REPLACE ROOF CIVIC CENTER

FRANKFORT, KENTUCKY

"AS-BUILT" NOTE: 25 July 2005

REPLACE ROOF -- CIVIC CENTER FRANKFORT, KENTUCKY		DRAWING NO. A-1
AS BUILT DATE 25 JULY 2005	ROOF PLAN	
DRAWN BY <i>MARTIN</i>	COMMONWEALTH OF KENTUCKY FINANCE AND ADMINISTRATION CABINET DEPARTMENT FOR FACILITIES MANAGEMENT DIVISION OF ENGINEERING FRANKFORT, KENTUCKY	
CHECKED BY <i>MARTIN</i>	WILLIAM C. MARTIN, P.S.C. ARCHITECTS-ENGINEERS 620 EUCLID AVENUE LEXINGTON, KENTUCKY	
A & B FILE 573-75	REVISED BY DATE 18 Nov. 2003	
AGENCY AUTHORIZED AGENT	APPROVED FOR PROGRAM CONCEPT ONLY DATE	
DIVISION OF ENGINEERING	APPROVED FOR PROGRAM CONCEPT ONLY DATE

ROOF PLAN 1/16" = 1'-0"
PLAN NORTH

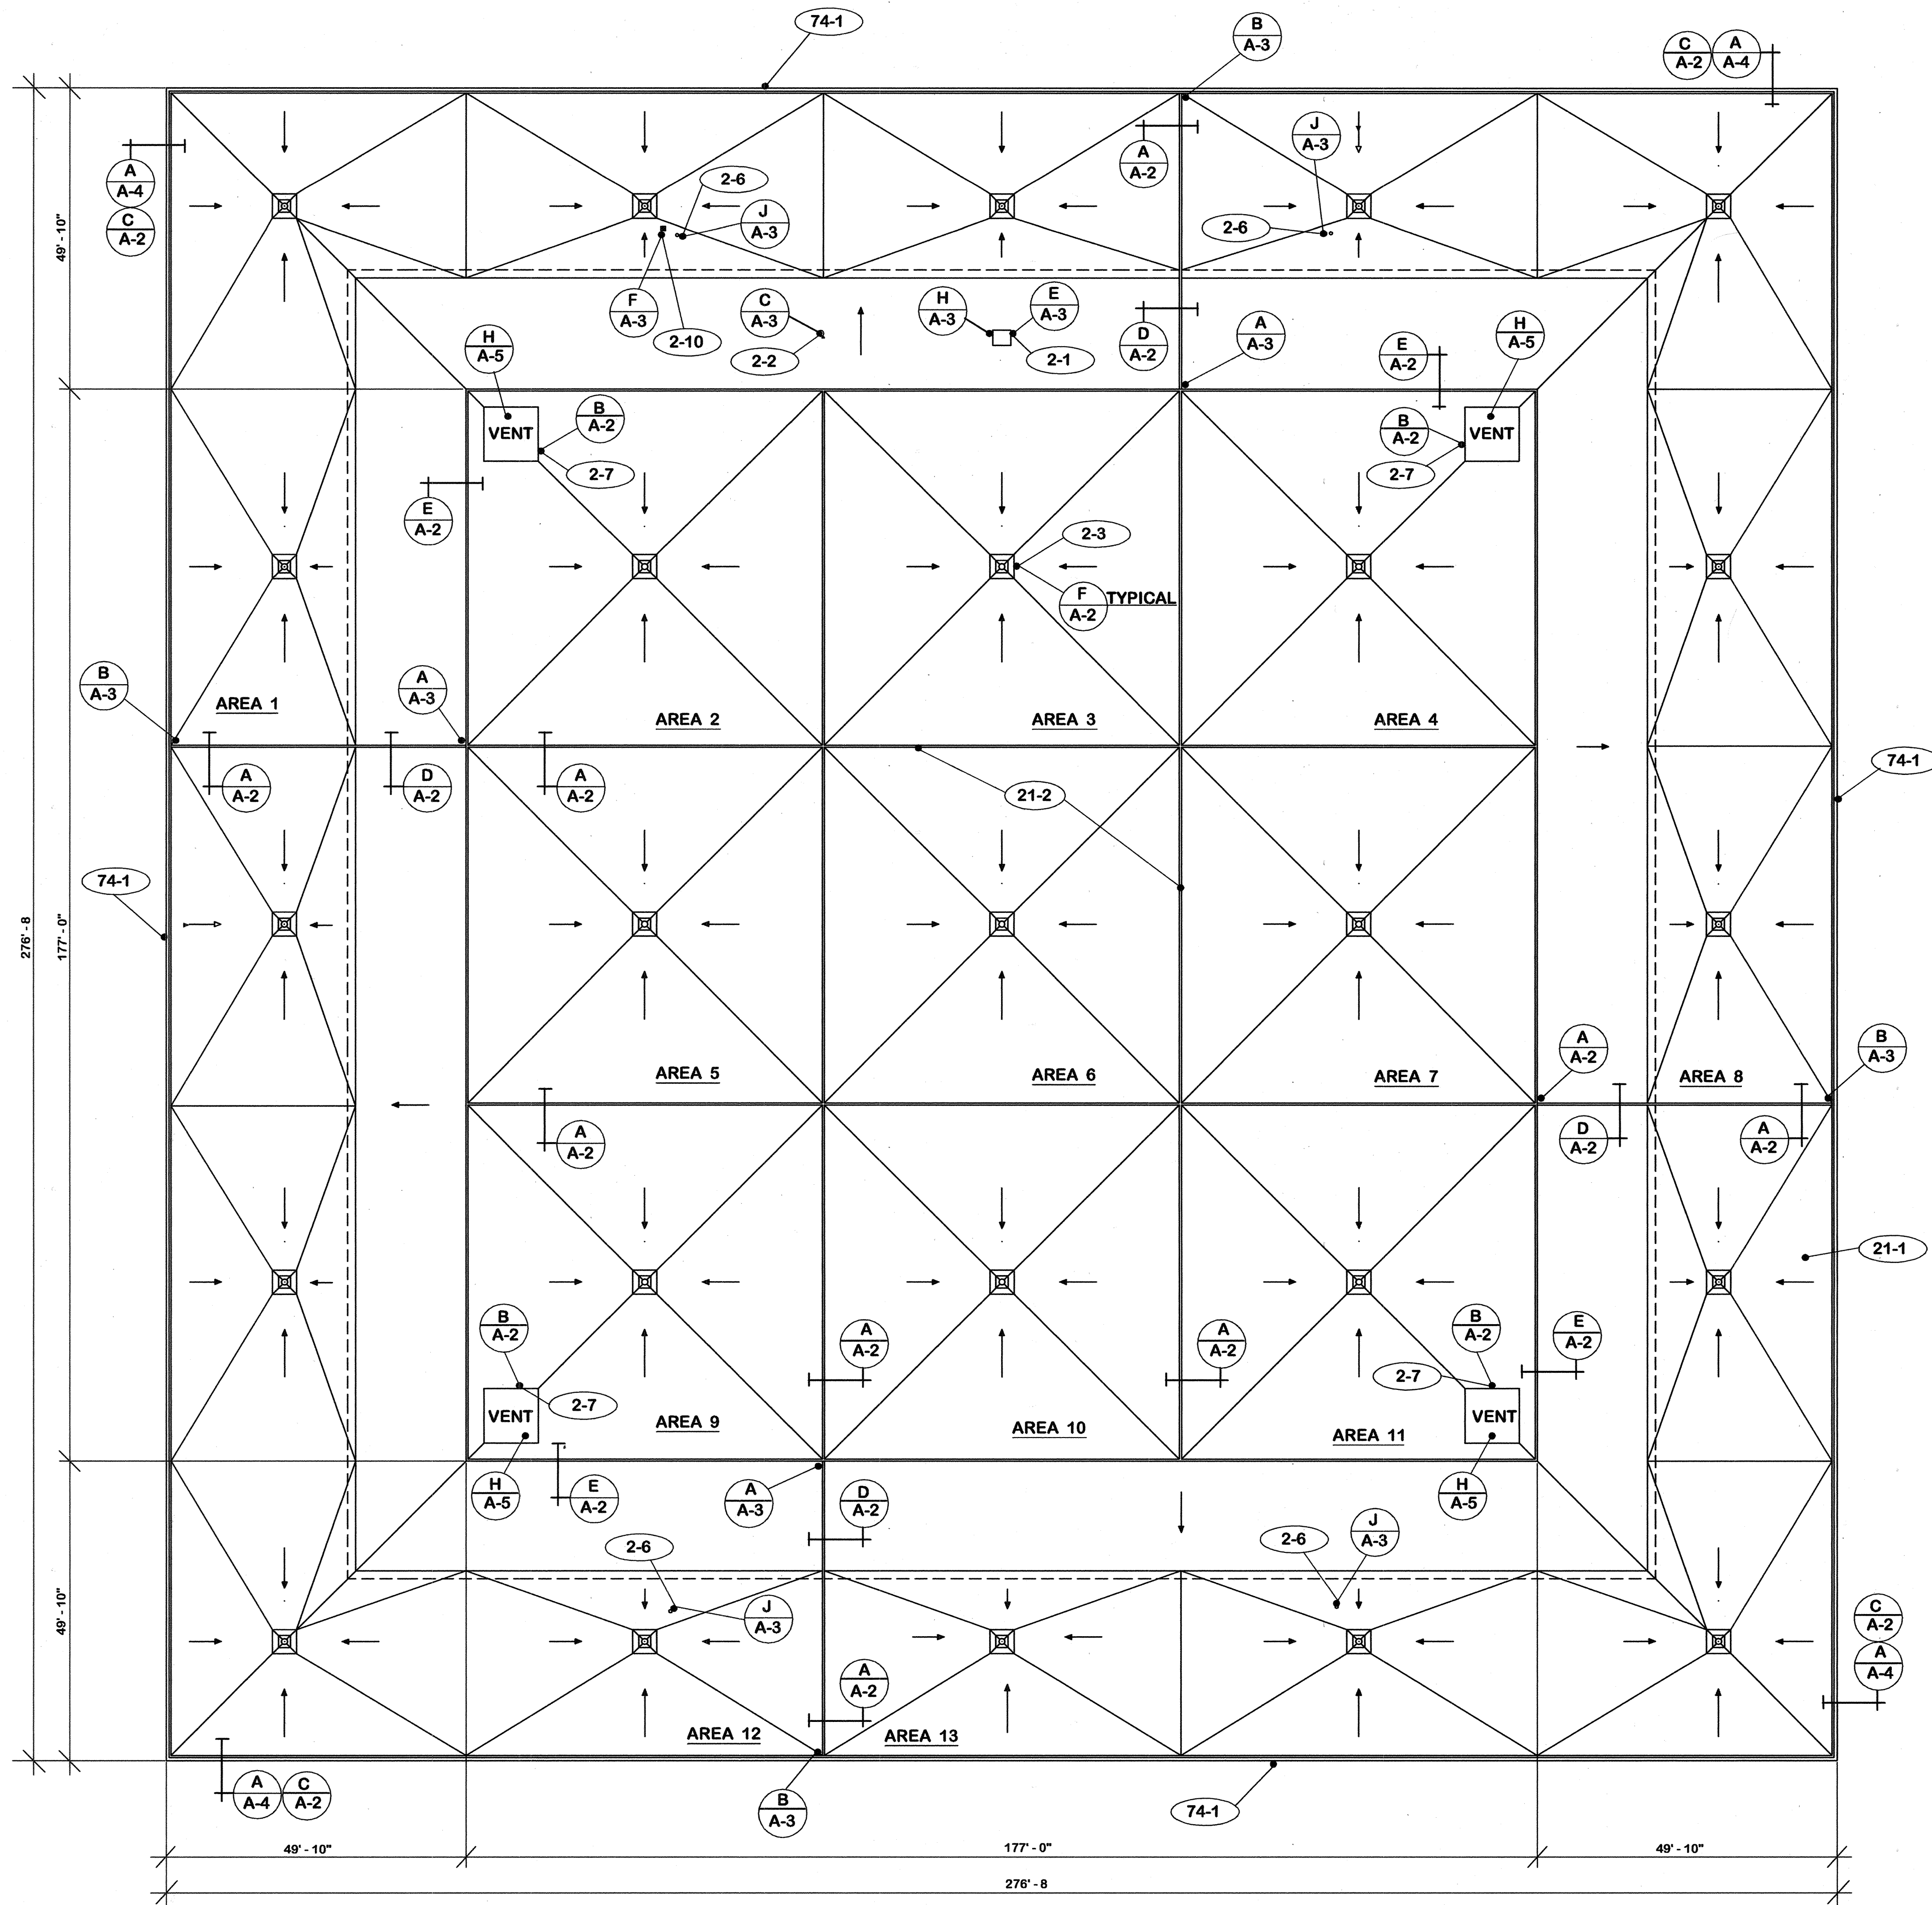
"AS-BUILT" NOTE:

- Delete notes 2-5, 21-6 and 6-14.
- Add notes 2-14 through 2-21.
- Change total number of drawings to 12.

SECTION C-A-2 3" = 1'-0"

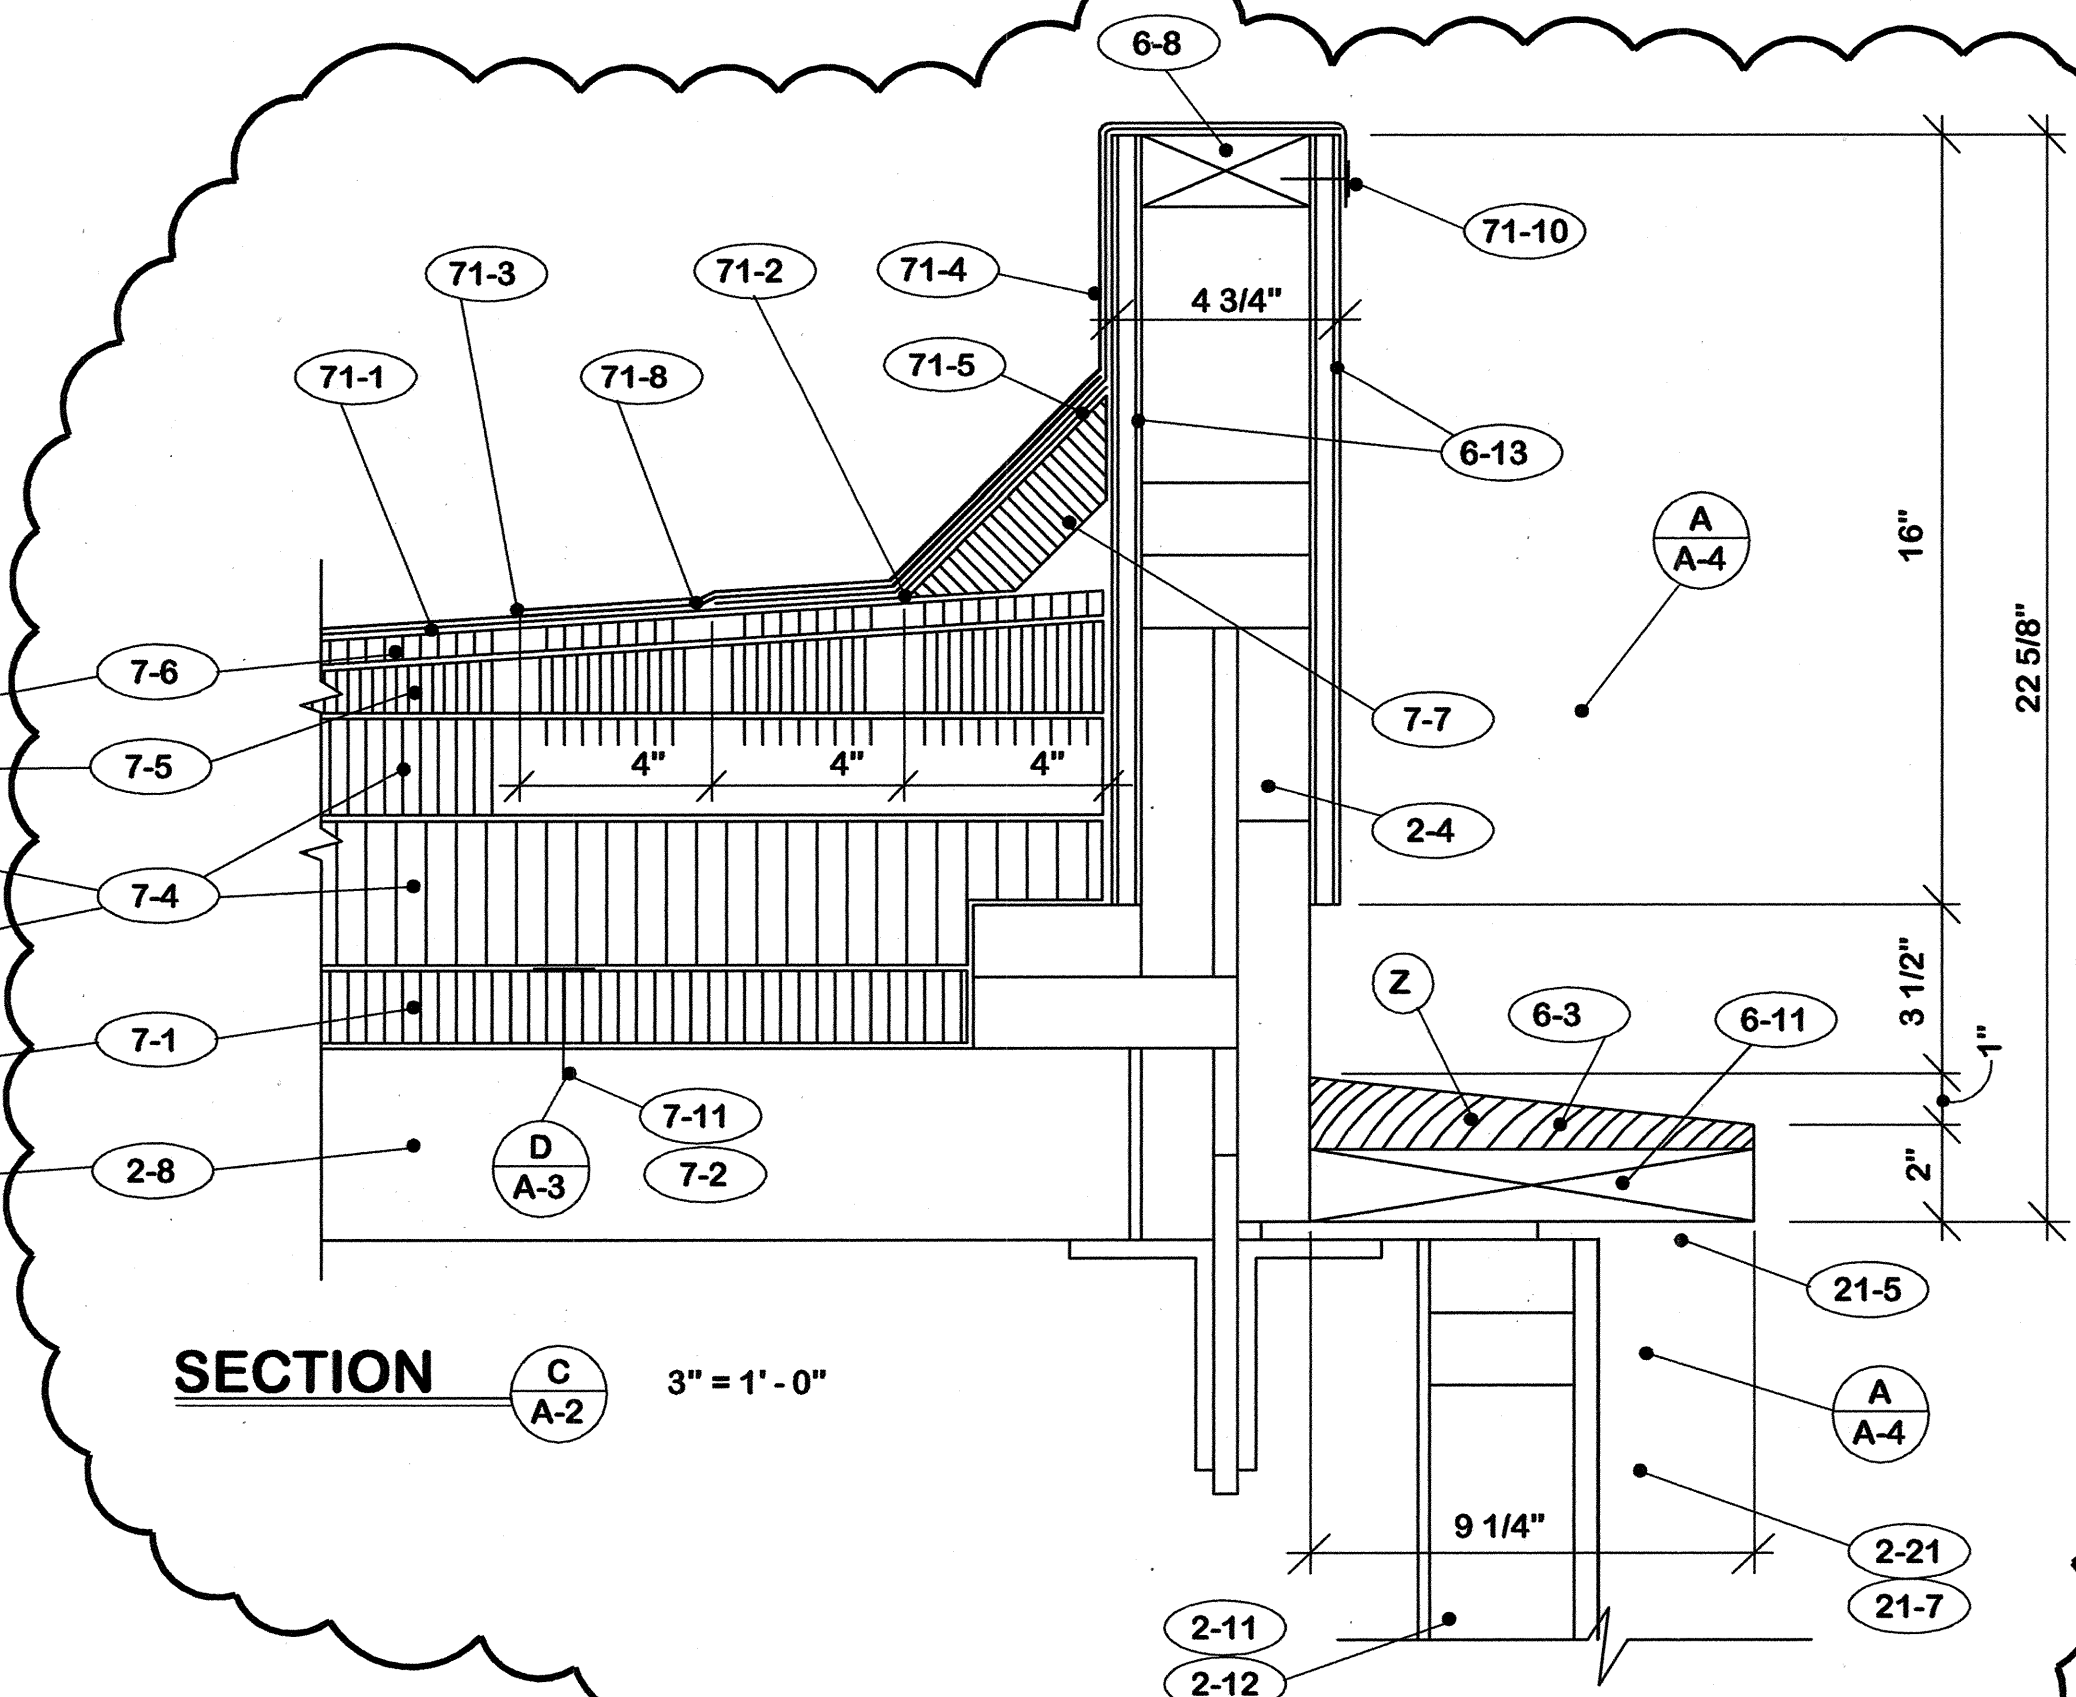
1. Add notes 7-10 and 7-11.
2. Section C/A-2 - Delete note 21-6. Add notes 2-21 and 21-7.
3. Change total number of drawings to 12.
